City of Surrey PLANNING & DEVELOPMENT REPORT Application No.: 7923-0144-00

PROPOSAL:

- **Rezoning** from RF to CD (based on RM-70)
- Development Permit

to permit the development of a six-storey apartment building consisting of 66 units.

PARKADE 1

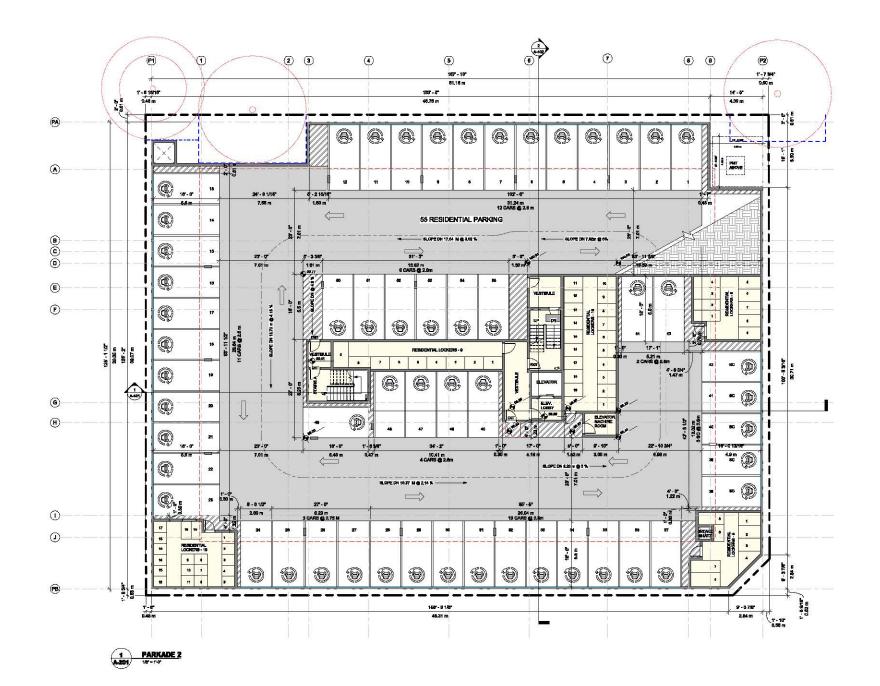
- Underground parking layouts have been revised. Width of all drive aisles complies with the Zoning Bylaw. Width of the drive aisle in front of stall 8 is 23 feet. However, we see the possibility for parking layout improvement, and we'll introduce them after the Council Meeting.

PARKADE 2

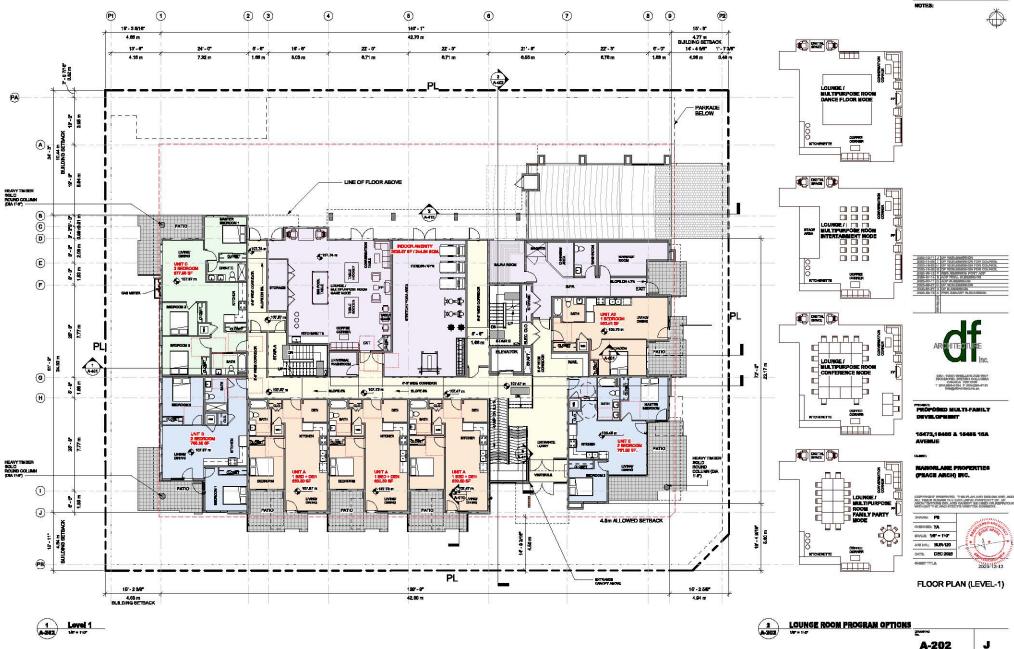
- Consider reviewing the layout of below grade storage spaces and exploring the possibility of providing additional areas for large items.
- Storage spaces layouts have been revised. Several bigger lockers have been provided for larger items.
